**Univent Replacement at Stony Point, Thiells, and West Haverstraw Elementary Schools**

**MSA File No. 43040**

**NOTICE TO BIDDERS**

Re: **ADDENDUM NO. 1**

© COPYRIGHT, MICHAEL SHILALE ARCHITECTS LLP, ALL RIGHTS RESERVED.  
**PROPOSED FIRST FLOOR RCP**  
 Drawing No. **SPES-A-401**

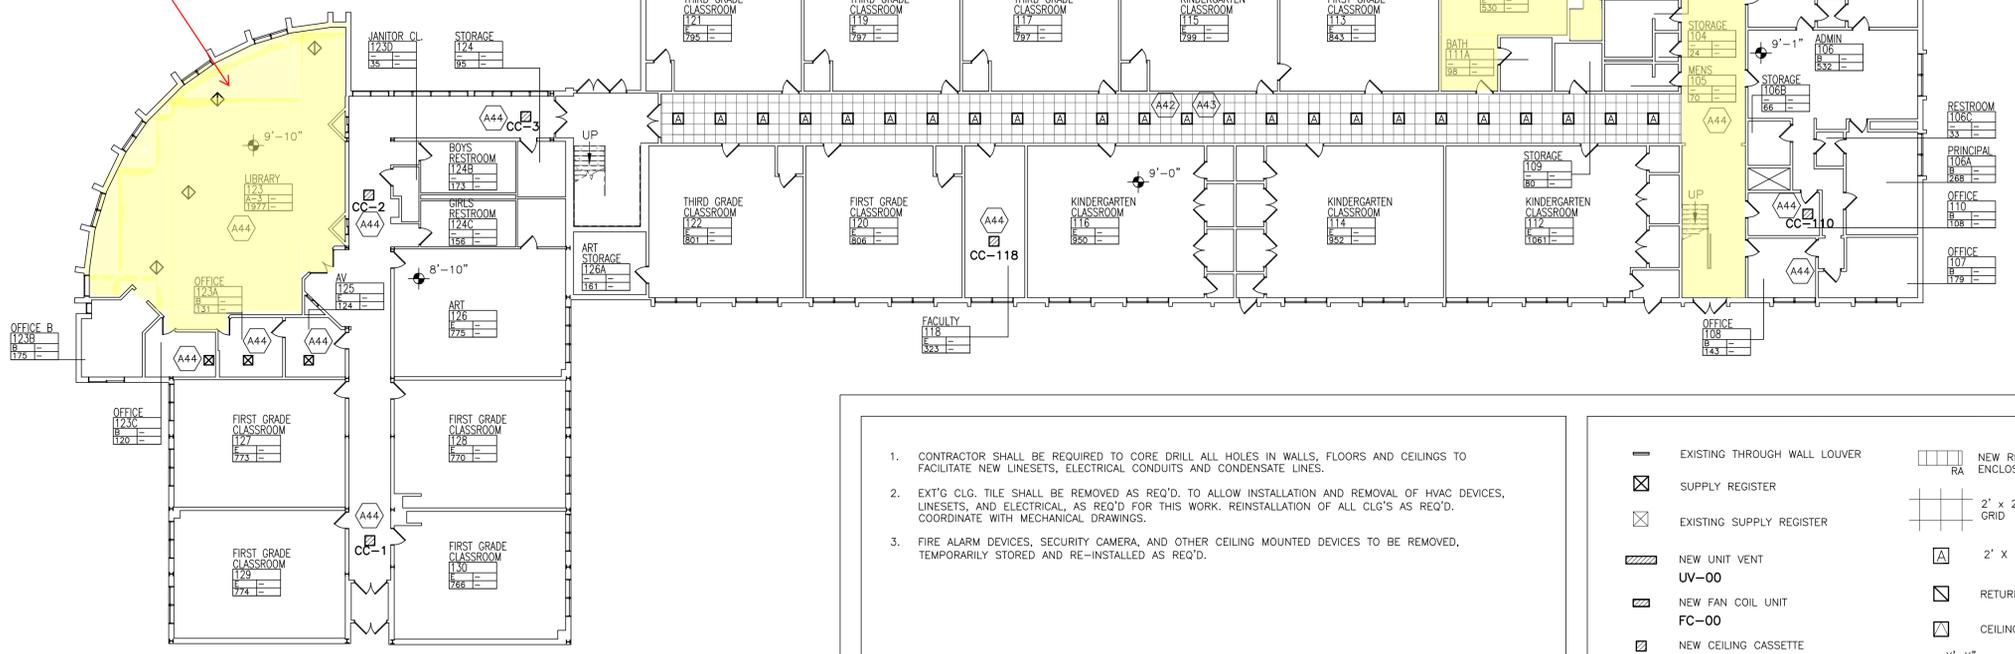
- 11) Ceiling Replacement at Stony Point Elementary, Main Corridor, is no longer required. See attached Markup drawing SPES-A-401 highlighting the corridor location. The highlighted corridor ceiling had been previously replaced. Exclude area from Alternate No. 100.

CEILING AND LIGHTING REPLACEMENT IN HIGHLIGHTED ROOMS TO BE REMOVED FROM ALTERNATE NO. 100. AND TO BE CHANGED TO BASE BID. CEILING HEIGHTS TO MATCH EXISTING HEIGHT

CEILING AND LIGHTING REPLACEMENT IN HIGHLIGHTED ROOMS TO BE REMOVED FROM ALTERNATE NO. 100. AND TO BE CHANGED TO BASE BID. CEILING HEIGHTS TO MATCH EXISTING HEIGHT

Drawing No.: **TES-A-402**

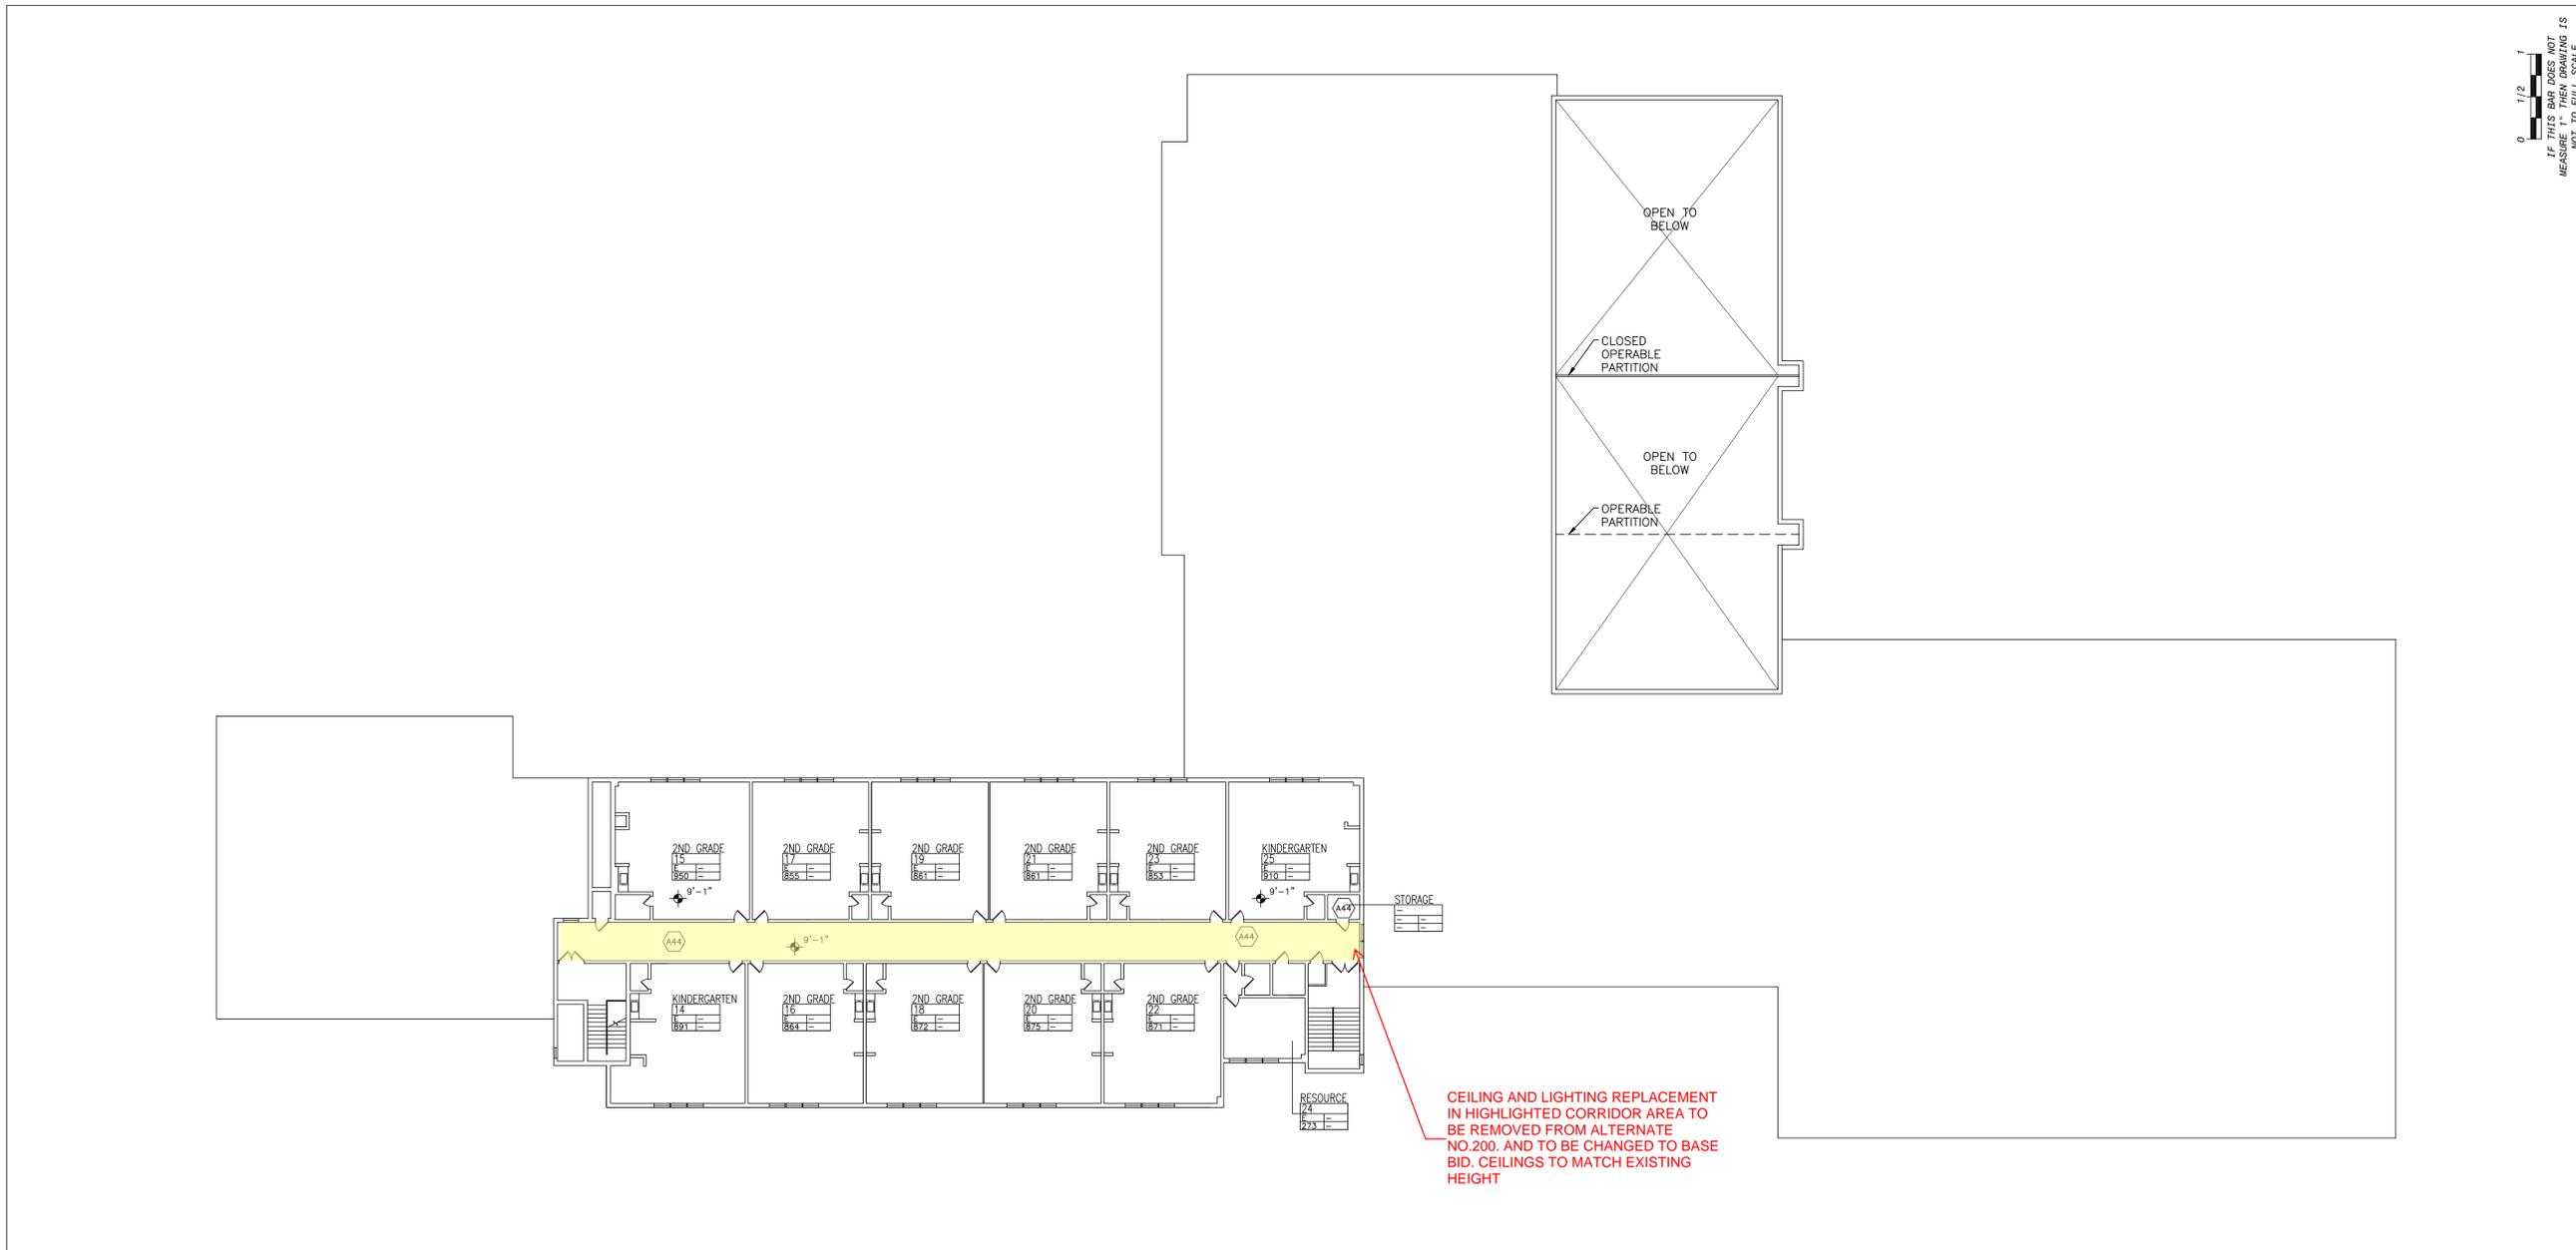
- 12) Thiells Elementary School and West Haverstraw Elementary School Ceiling Replacement. See attached Markup drawings TES-A-401, TES-A-402, WHES-A-401 & WHES-A-402 highlighting the corridor location. The ceiling replacement of the highlighted corridor ceilings will now be base bid. Exclude area from Alternate No. 200 & 300.

ROOF DETAILS  
Drawing No. A-500

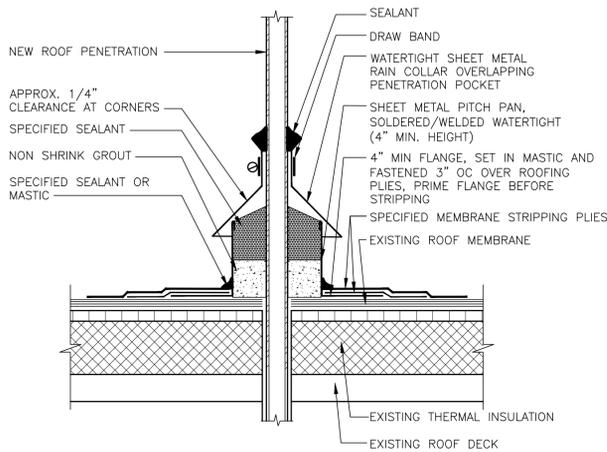
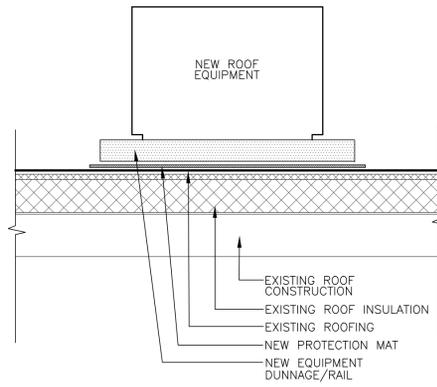
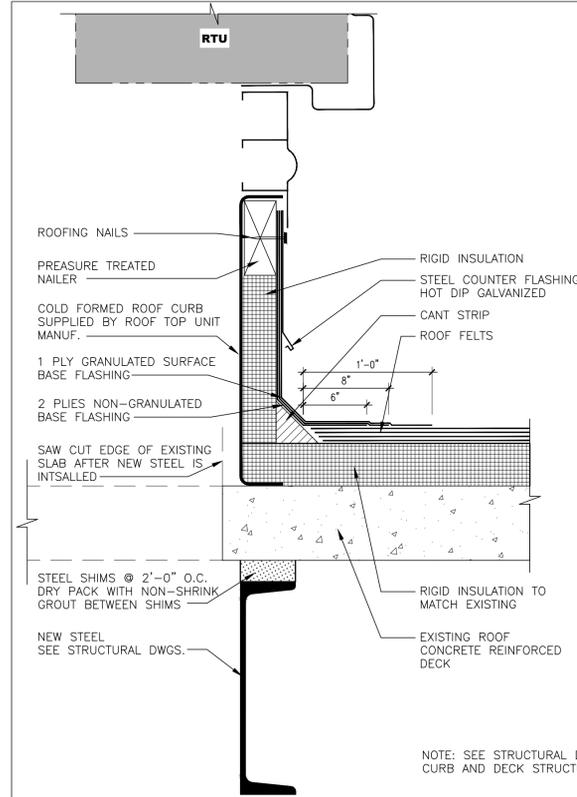
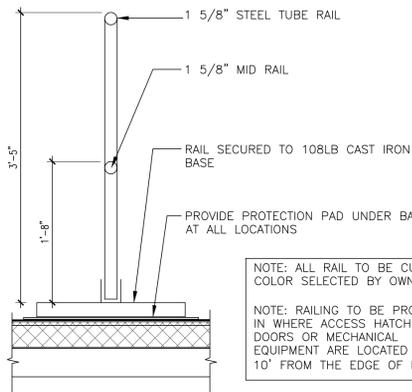
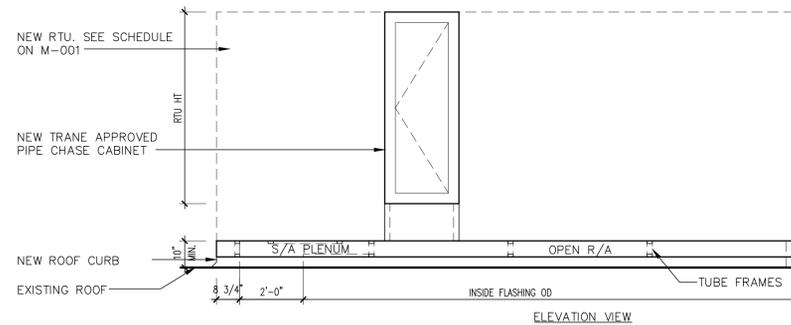
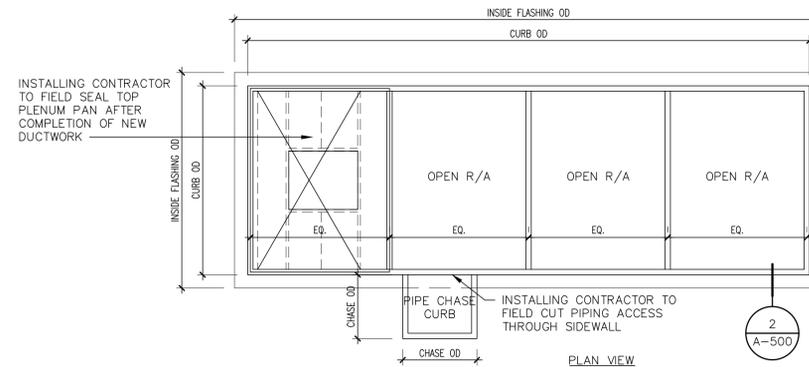
- 17) Equipment Screening at Thiells Elementary School and West Haverstraw Elementary School. See attached revised drawings TES-A-103, WHES-A-103, and A-500.
